# Access Compliance Report

## Public Rights-of-Way

| Intersection ID: 42489                  | Main Street: ALEXANDER MARTIN AV | Cross Street: LINA ARDREY LN            | Location: SW           |
| ADA ID: F49EBC220BF7                    | Ramp Type: PerpDiag              | Initial Pass/Fail: Fail                 | Overall Compliance: No |

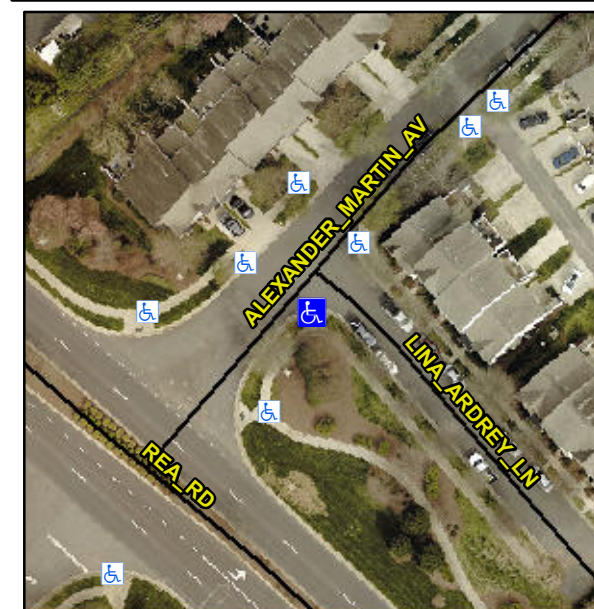
**R304.5.1**

| Compliance | Description           | Data  | Compliance | Description                 | Data  |
|------------|-----------------------|-------|------------|-----------------------------|-------|
| No         | Ramp Width (in)       | 35.0  | Yes        | Ramp XSlope (%)             | 1.1   |

**Remove & Replace Curb Ramp With Two New Directional Ramps or Equivalent.**
